CITY OF ALBUQUERQUE

RE: 9821 Buckeye St. NW
Grading and Drainage Plan
Engineer's Stamp Date: 01/28/21
Hydrology File: B13D011D

Based upon the information provided in your submittal received 01/28/2021, the Grading and Drainage Plan is approved for Grading Permit.

| ENGINEER'S SEAL  1/28/21 DAVID SOULE P.E. #14522 | LOT 19 BLK 2 U 2 KPH 9821 BUCKEYE ST. NW GRADING AND DRAINAGE PLAN  P.O. BOX 53924 ALBUQUERQUE, NM 87199 (505) 321-9099 | DRAWN BY DEM DATE 1-26-21 SHEET # C1 JOB # |

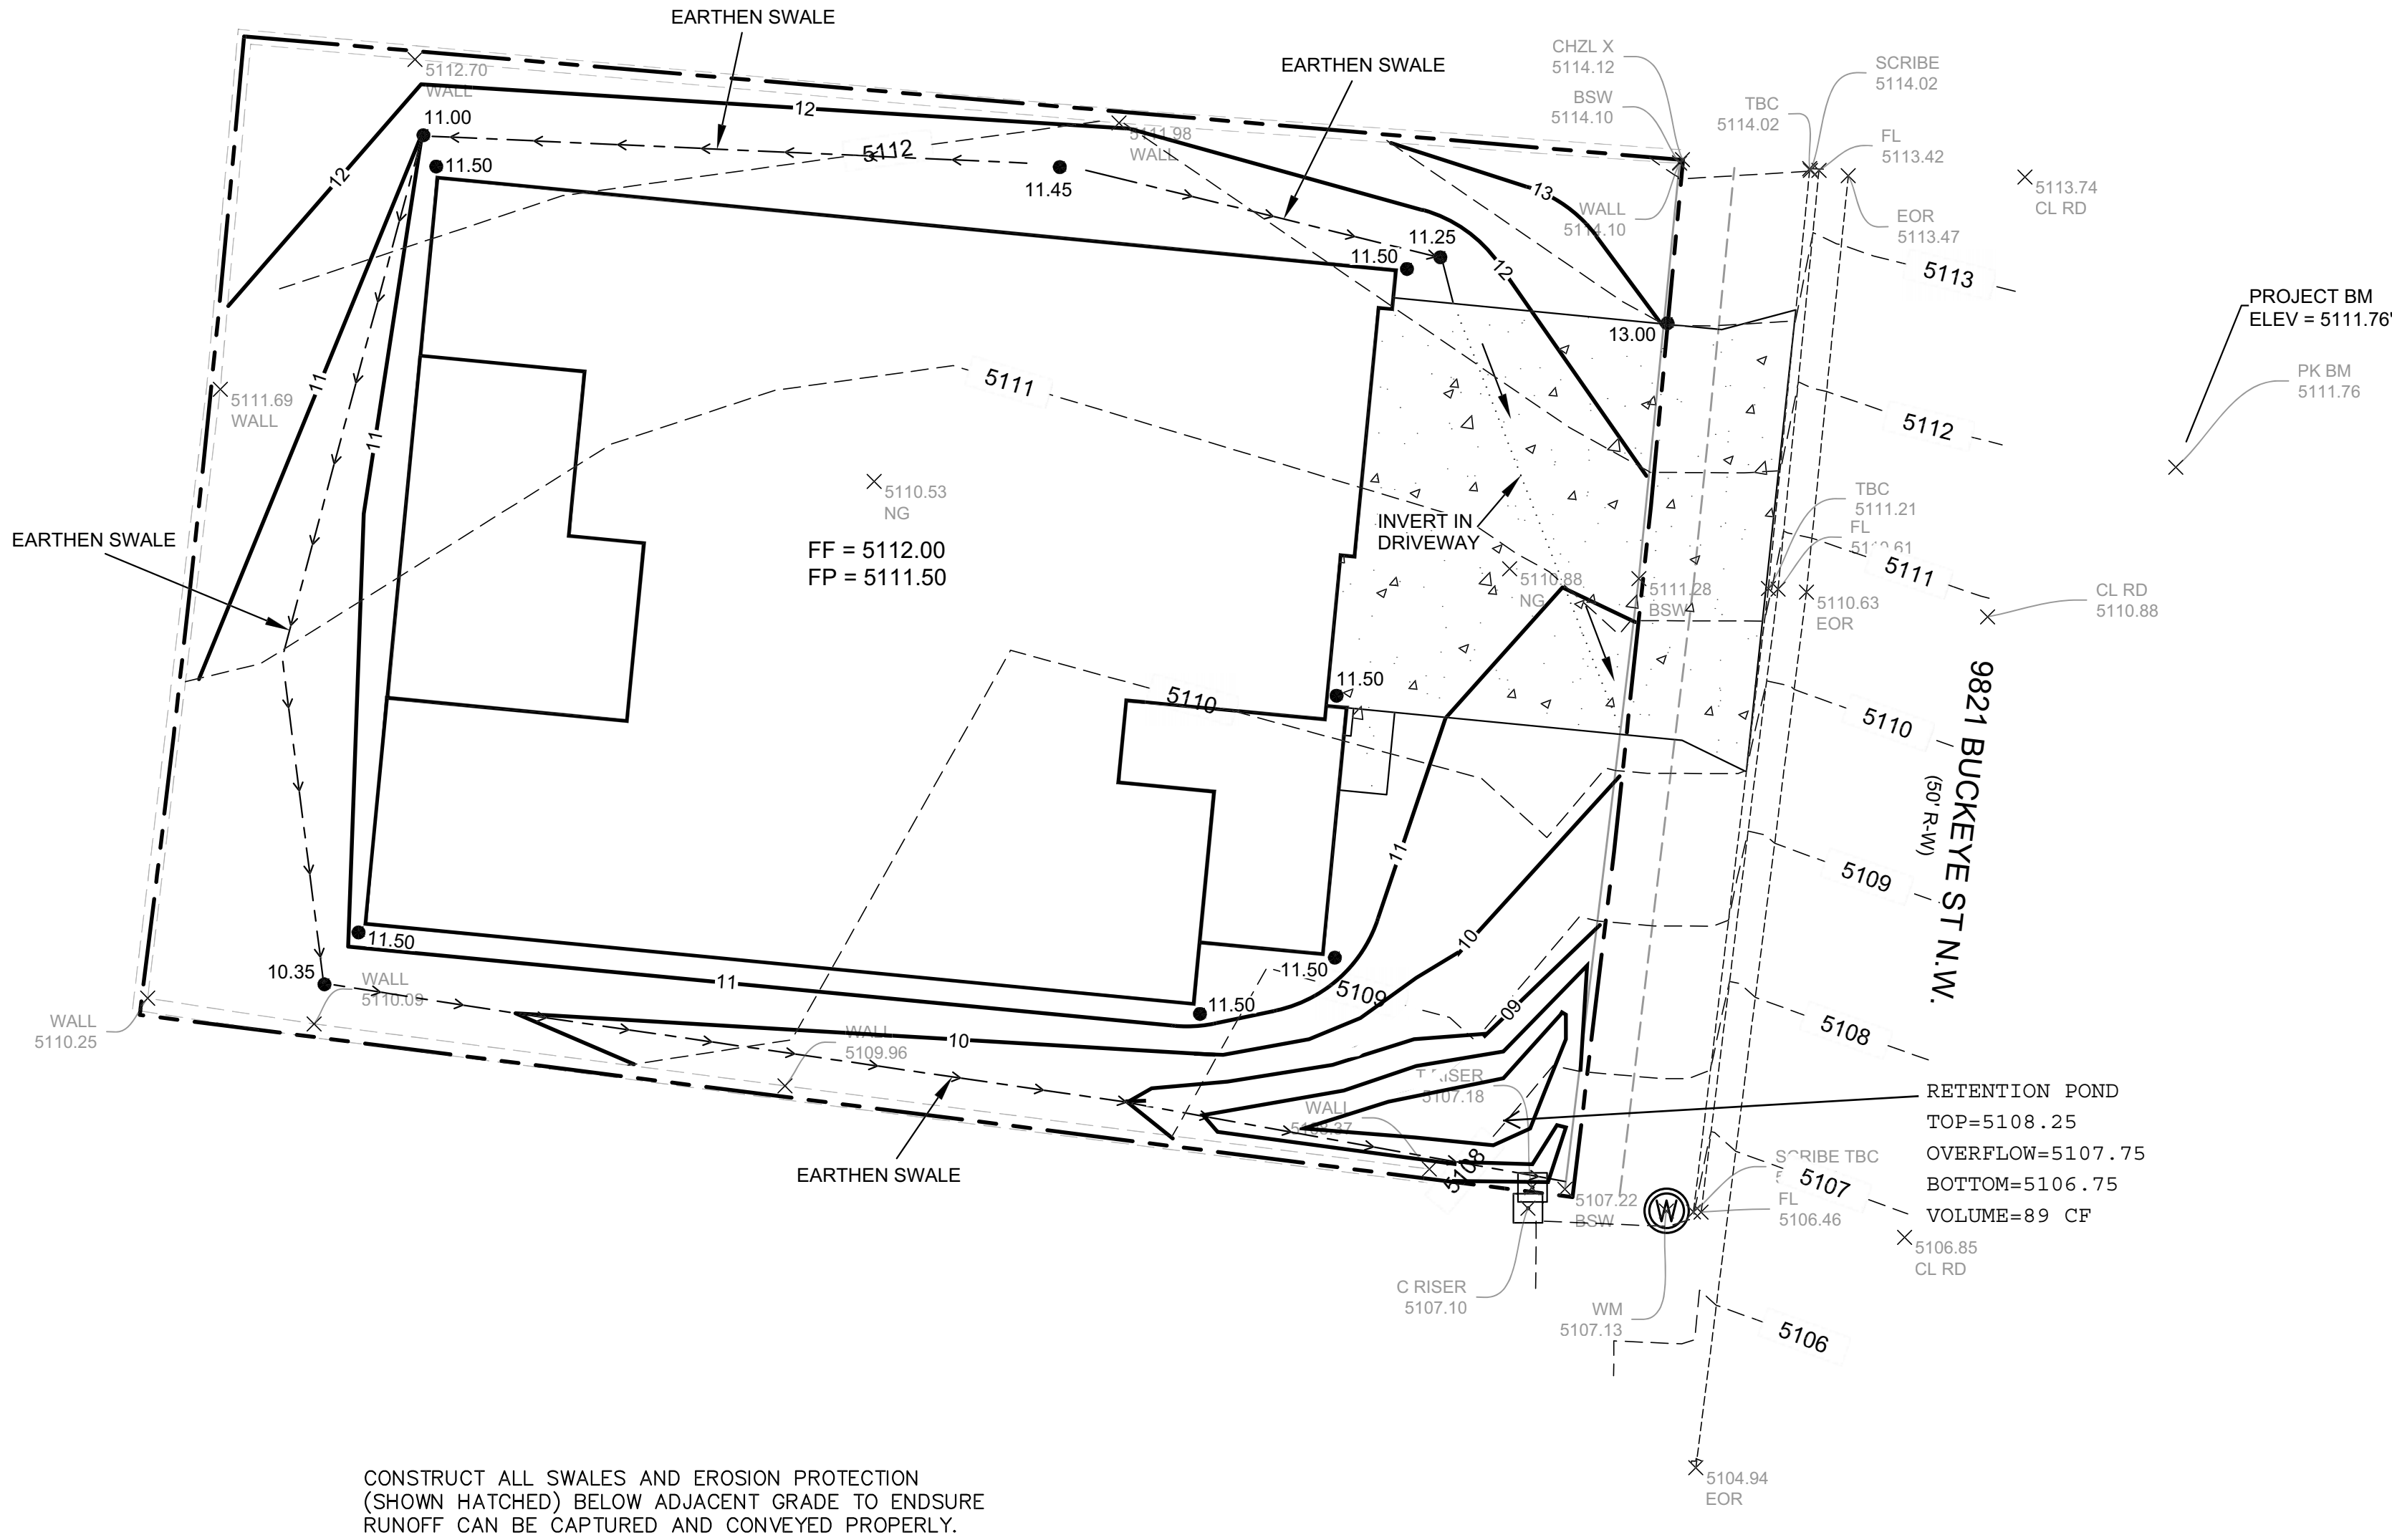
Once the grading is complete, a pad certification will be required prior to release of Building Permit. Please attach a copy of this approved plan in the construction sets for Building Permit processing along with a copy of this letter and the pad certification approval letter.

Prior to approval in support of Permanent Release of Occupancy by Hydrology, Engineer Certification per the DPM checklist will be required.
